ADDENDUM

ADDENDUM NO.: 03
PROJECT NAME: Kenwood Academy High School Link and Mechanical Project
PROJECT NO.: 05326
CONTRACT NO.: C1602
DATE OF ISSUE: October 25, 2022

NOTICE OF CHANGES, MODIFICATIONS, OR CLARIFICATIONS TO CONTRACT DOCUMENTS

MILESTONE 2: COMPLETE MEP SCOPE, NEW ELECTRICAL SERVICE, LANDSCAPE, INTERIOR RENOVATIONS AND ASSOCIATED WORK

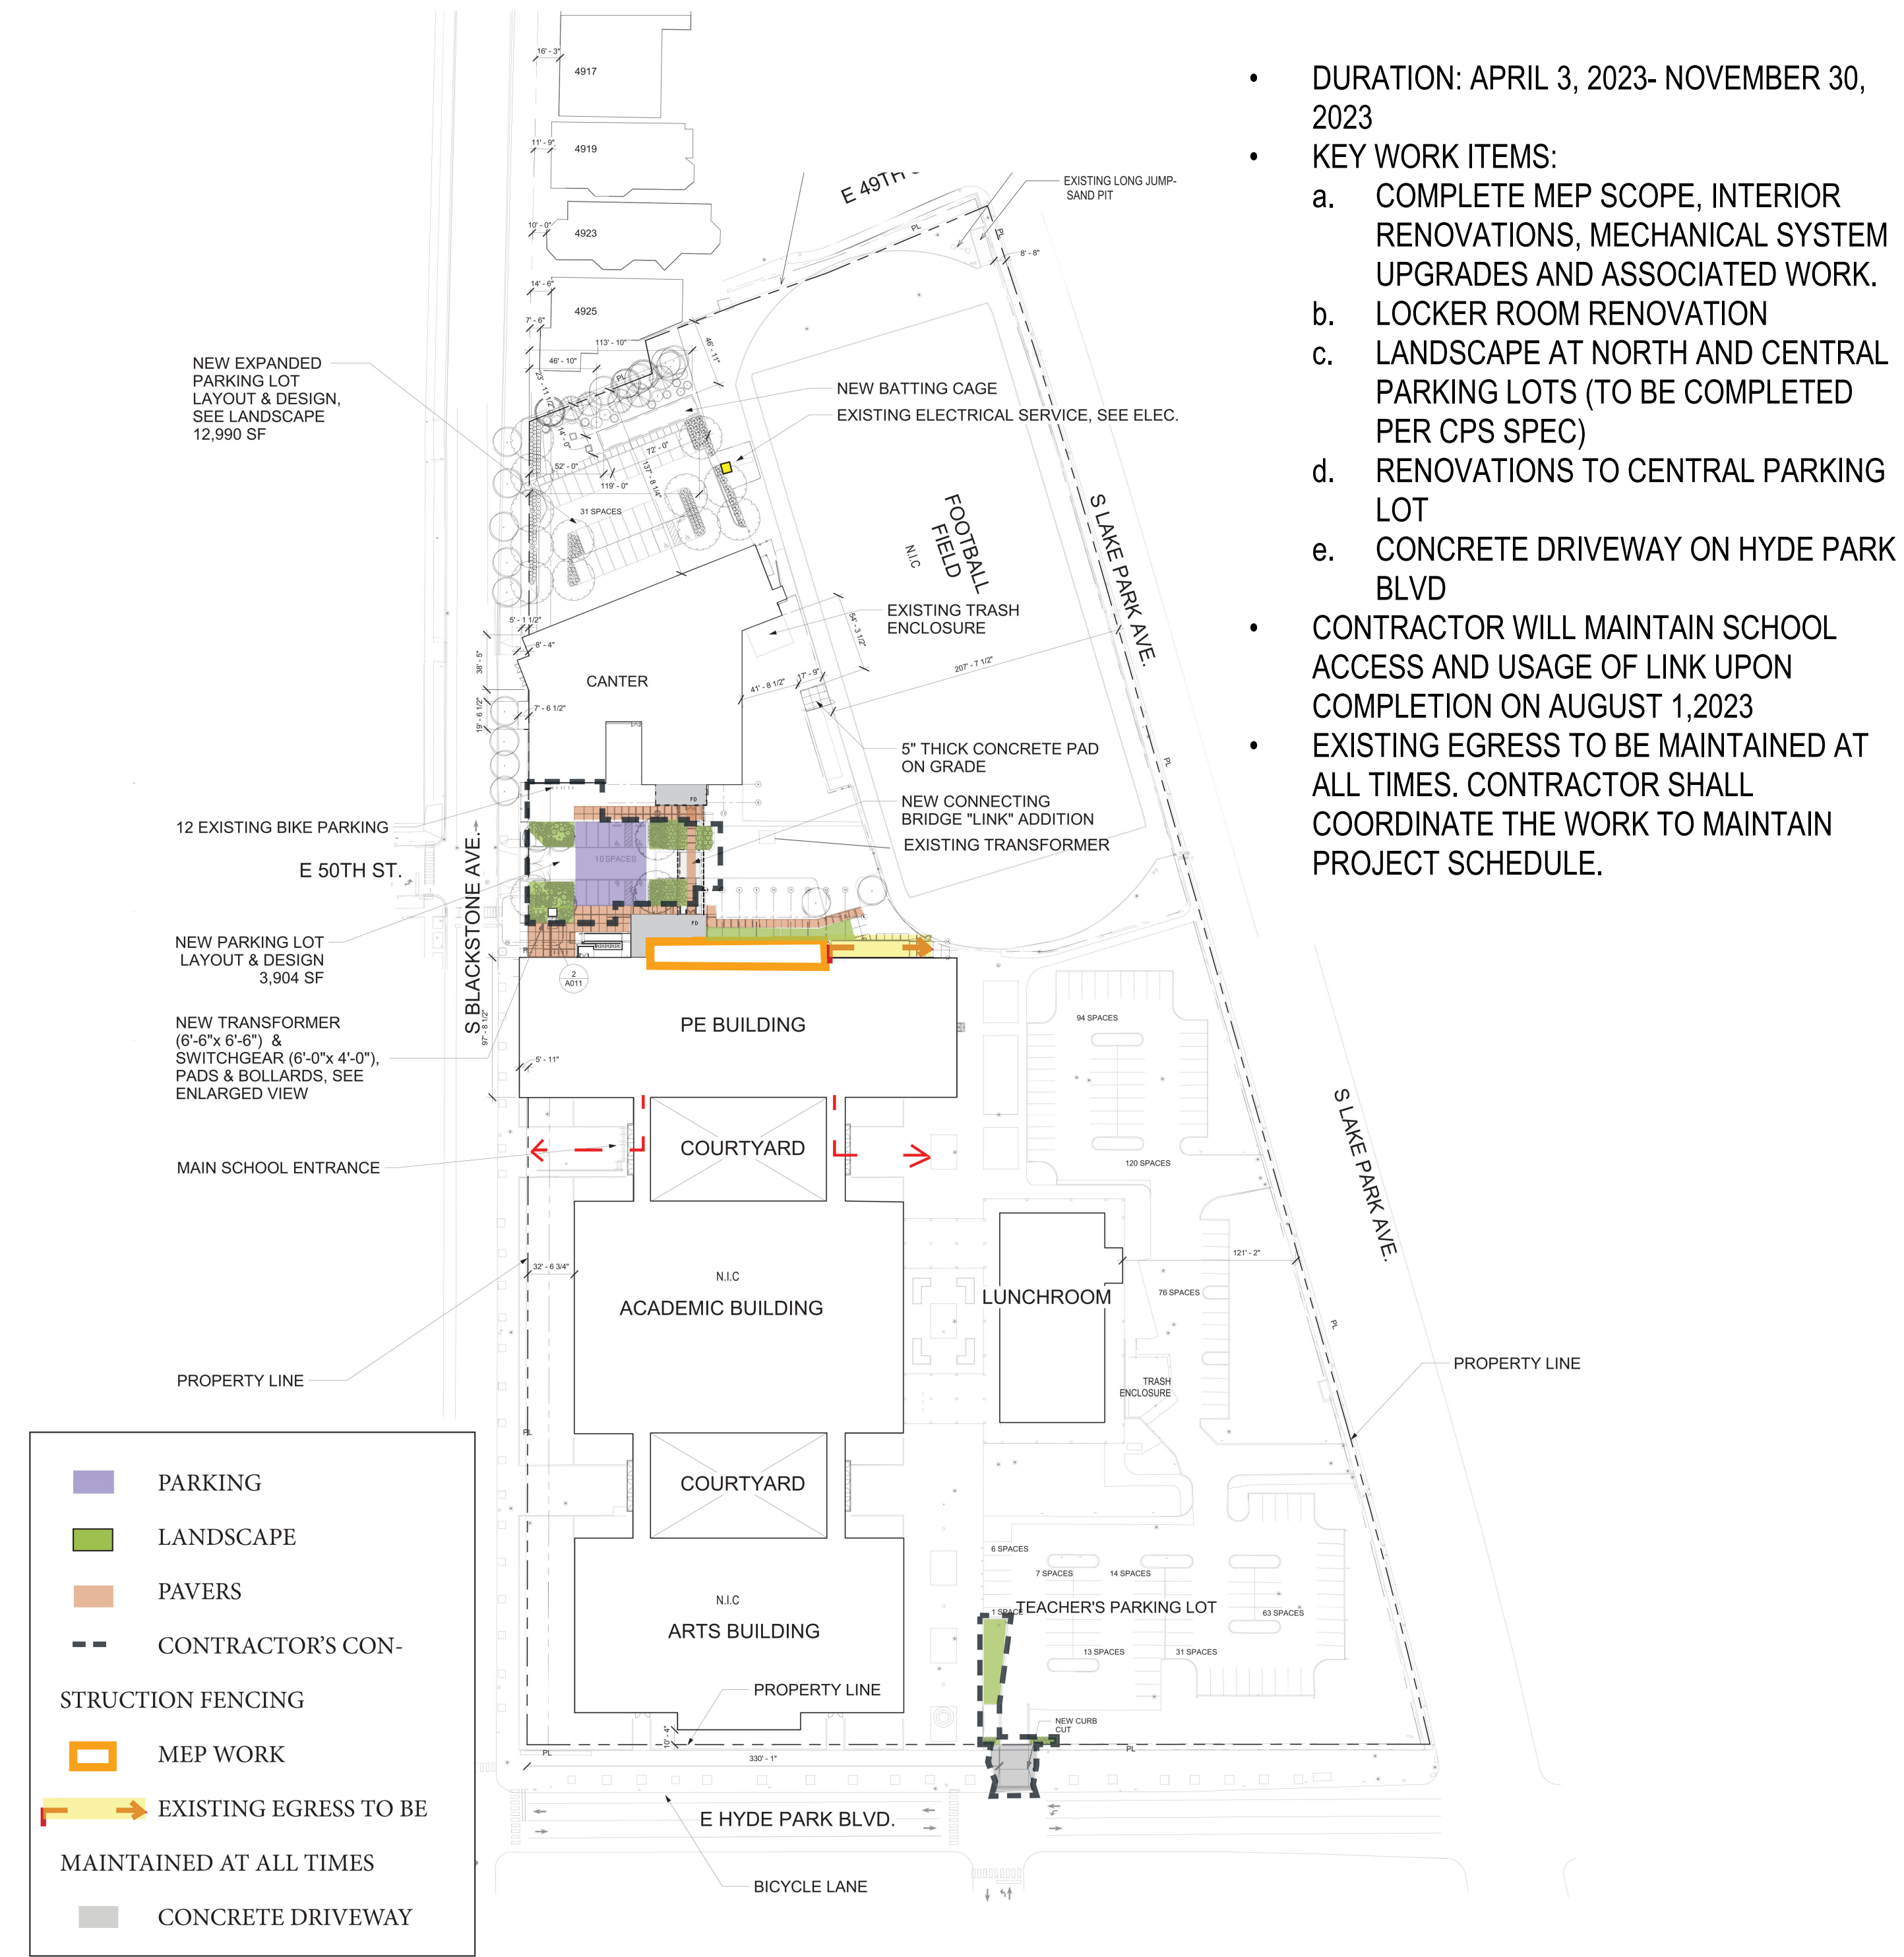
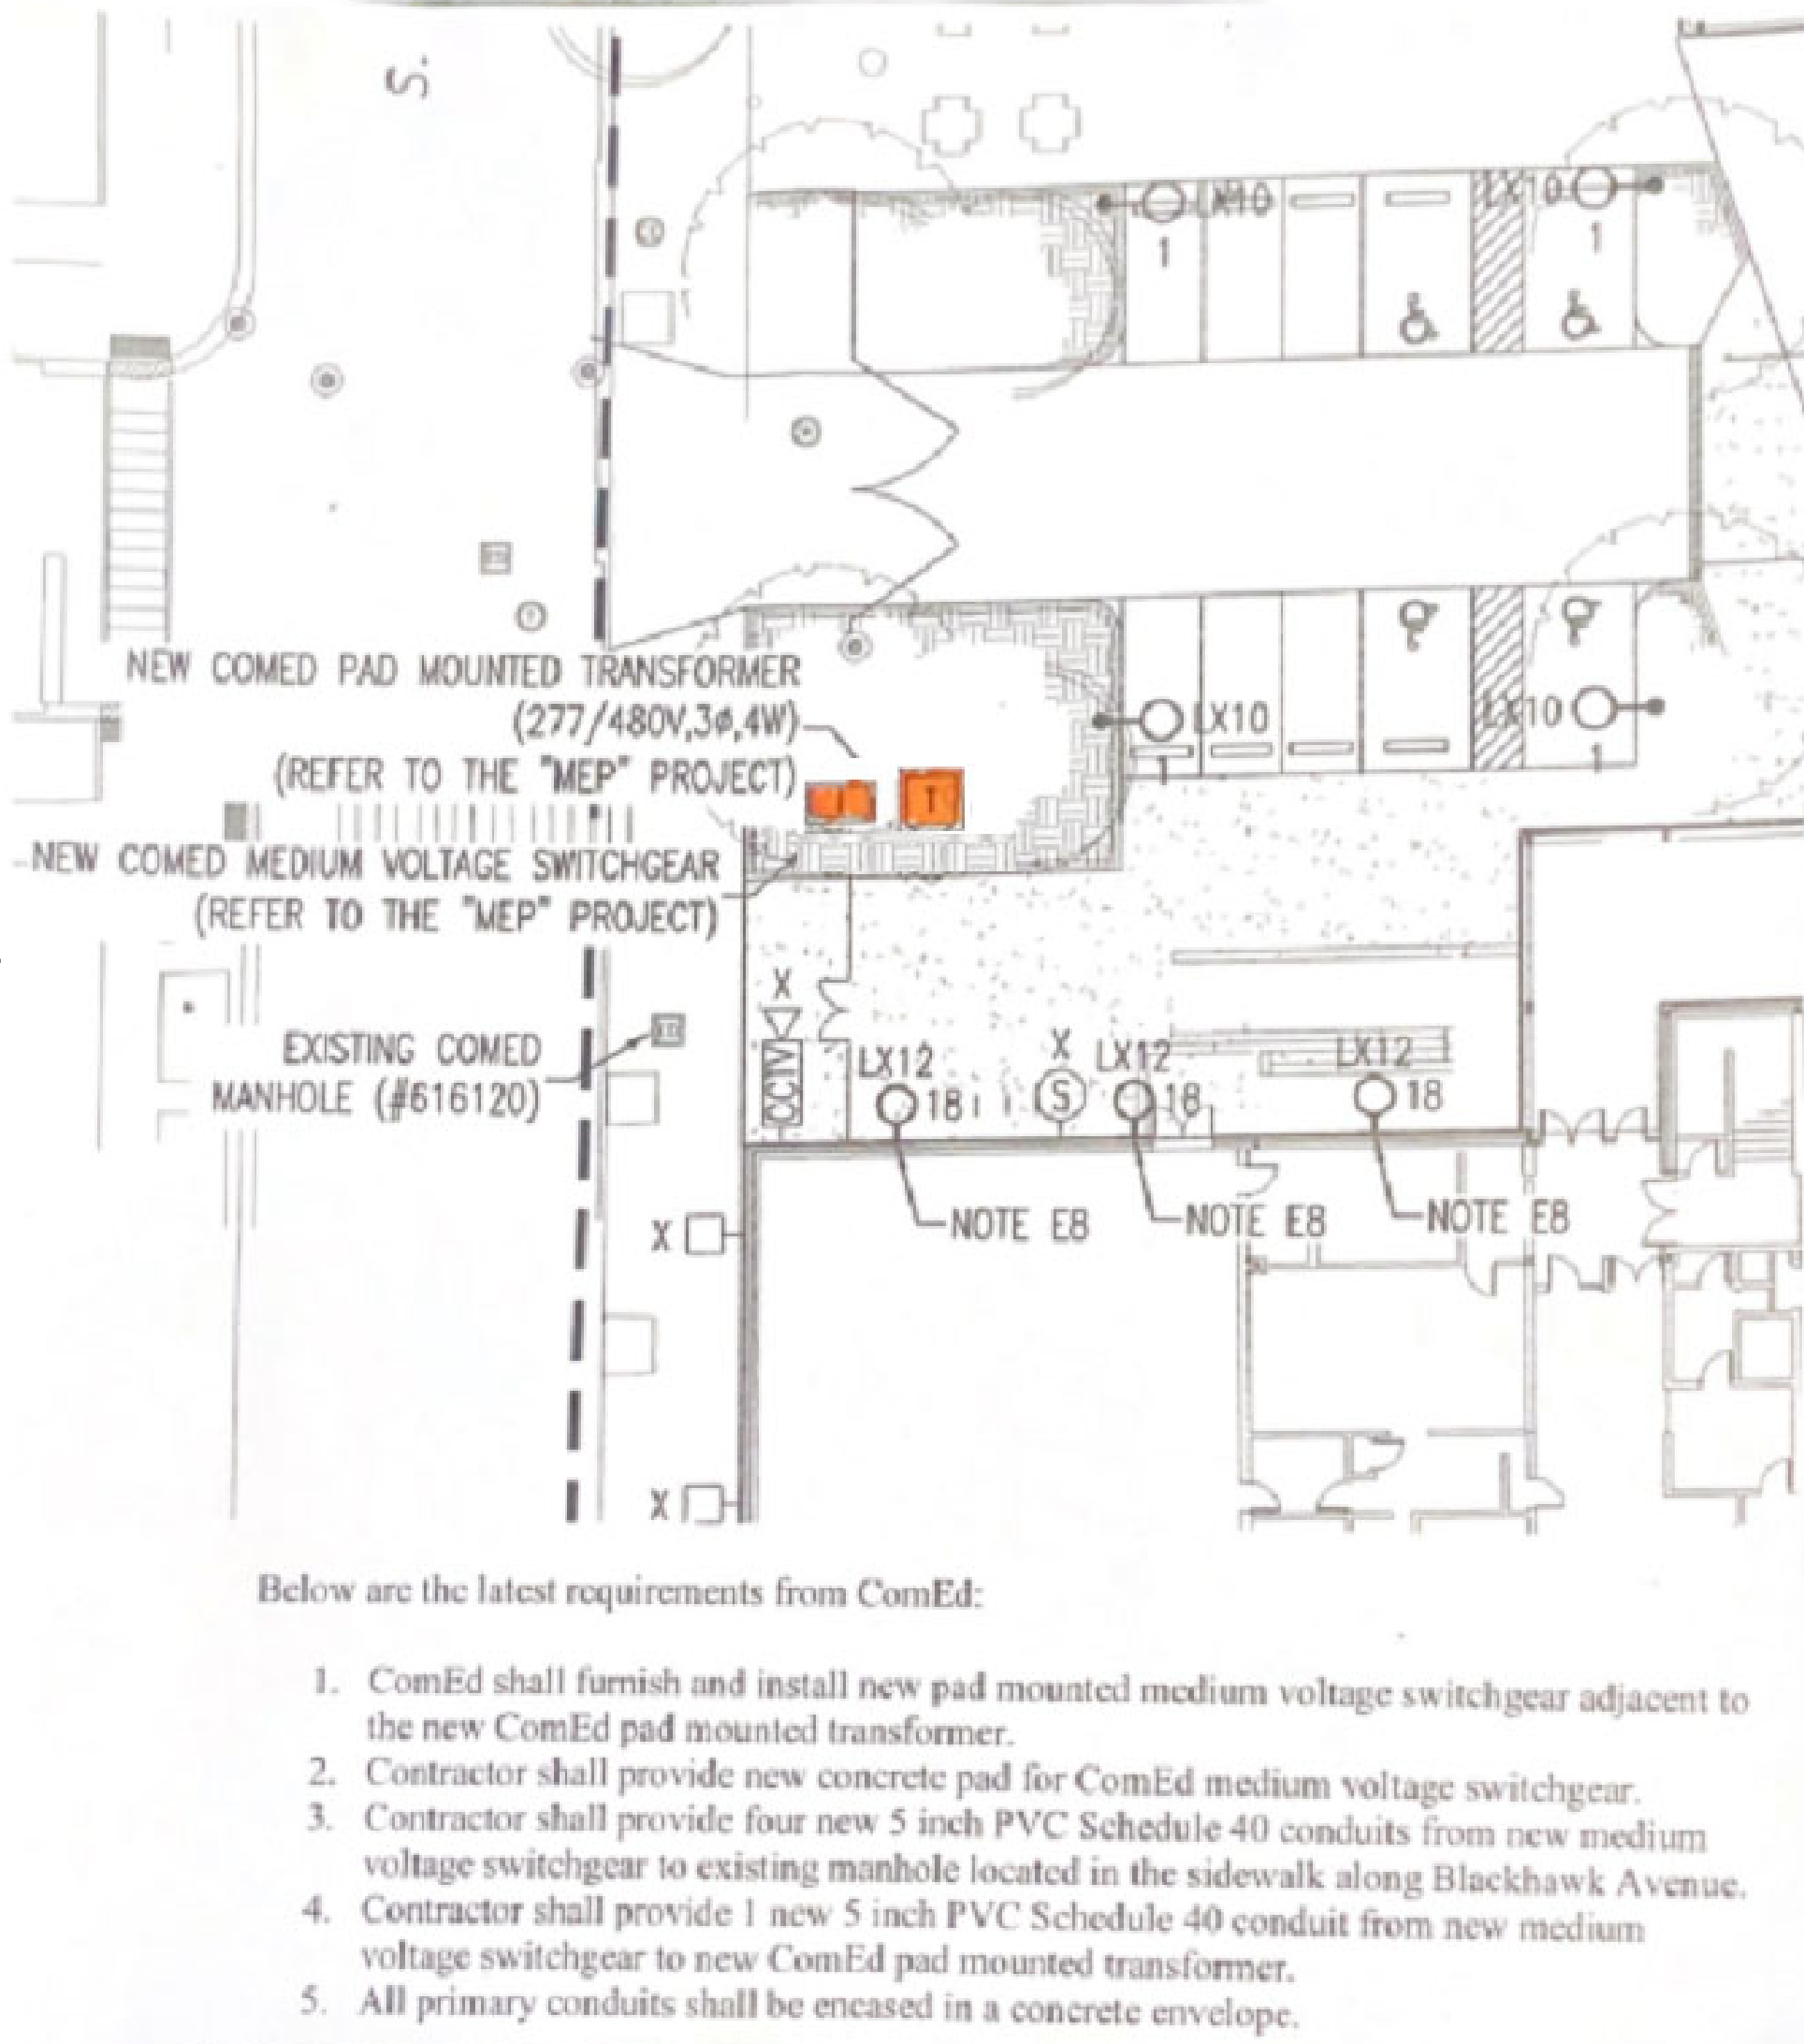
- Question:** The table of Contents in Book 1 for the Link Building lists specification section 01 14 11 Construction Operations and Site Utilization Plan as an included spec section, however this section does not appear in the spec book. Furthermore, the 3rd general note from the top on page G015 of the Link drawings makes reference to this spec section. Please issue specification section 01 14 11 Construction Operations and Site Utilization.
- Response:** Bidders are advised Specification Section 01 14 11, Construction Operations and Site Utilization Plan is stricken, and a revised Sheet G-015 with Specification Section 01 14 11 (third bullet) stricken is included in this Addendum No. 3.
